CITY OF CHICAGO - DEPARTMENT OF PROCUREMENT SERVICES
ADDENDUM NO. 3
FOR
REQUEST FOR PROPOSAL (“RFP”)
FOR OPERATION OF CONCESSIONS ON THE CHICAGO RIVERWALK
Specification No. 329656

ADDENDUM NO. 3

REQUEST FOR PROPOSALS (“RFP”) OPERATION OF CONCESSIONS ON THE CHICAGO RIVERWALK

SPECIFICATION NO. 329656

Attached is a survey of 31-35 East Riverwalk South.

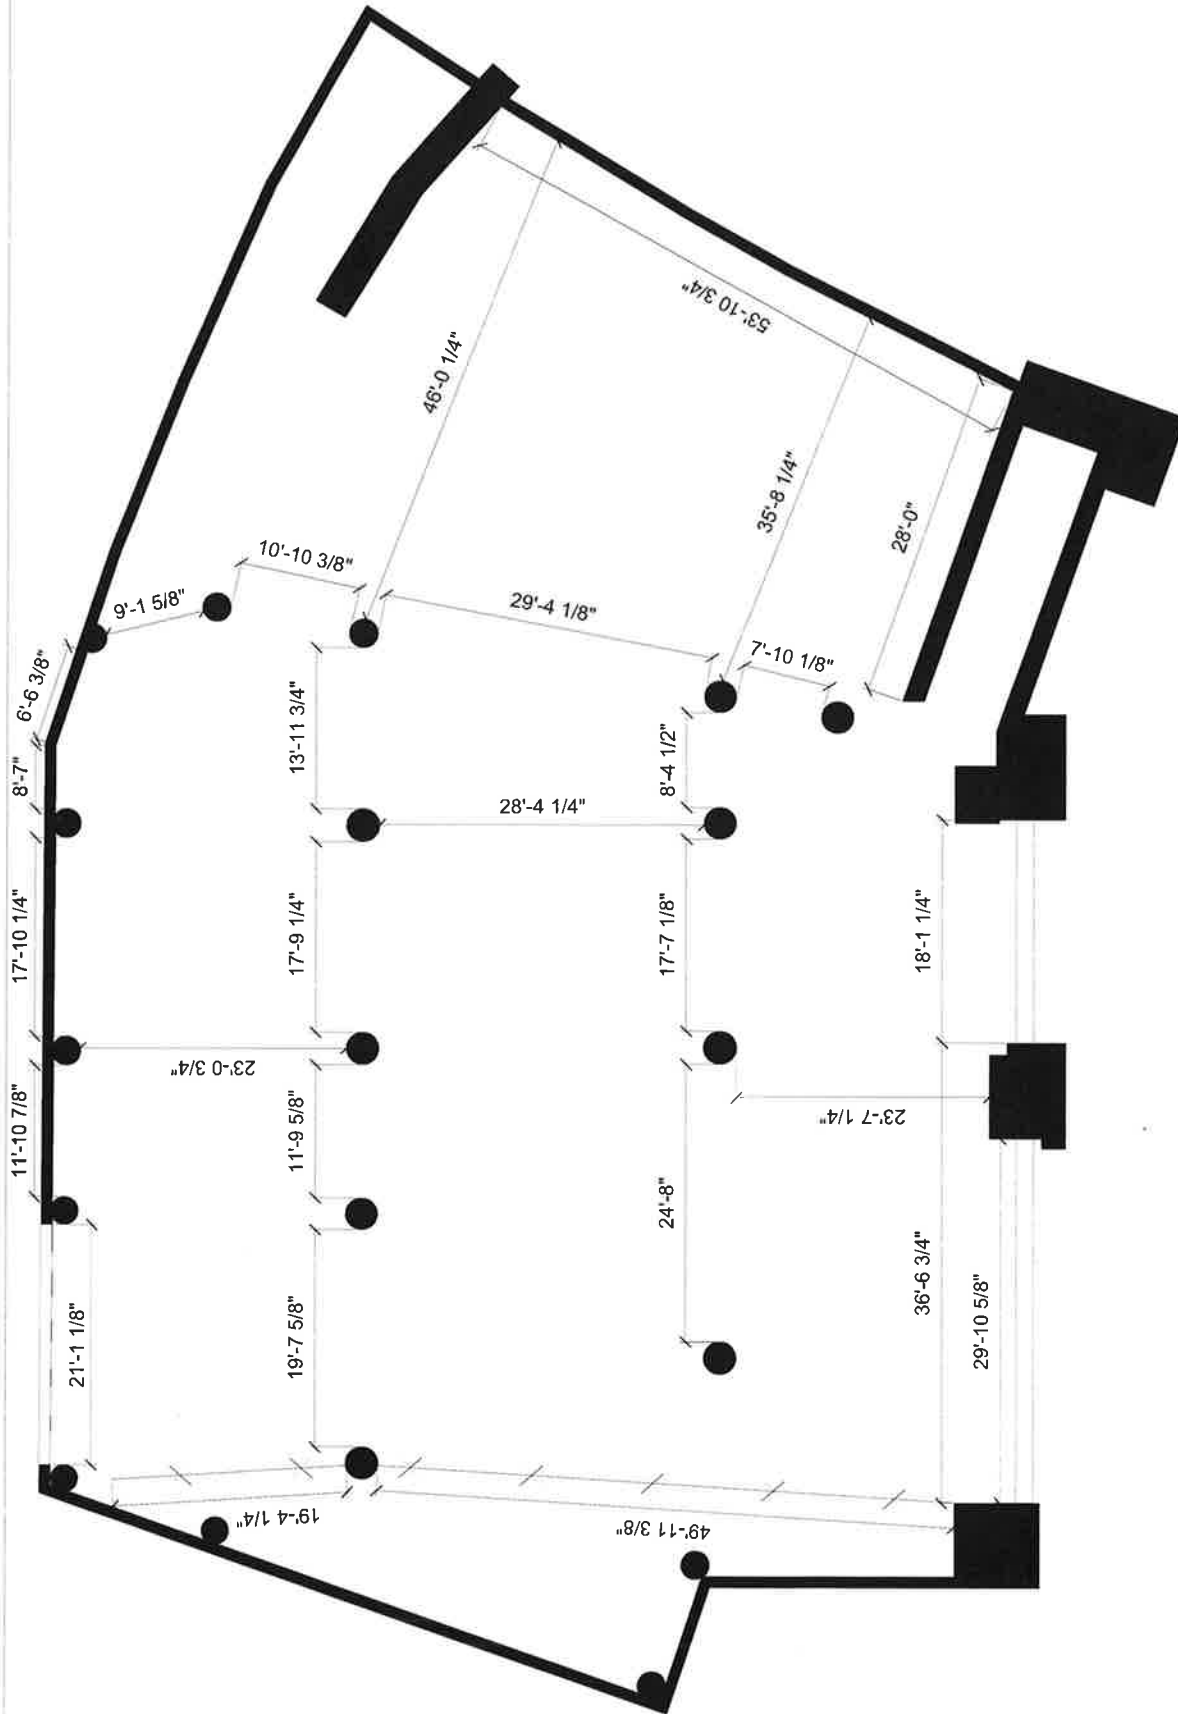
19. PDFs of location in the handbook are of poor resolution. Is it possible to get high res images of the site at 31-35 East Riverwalk?
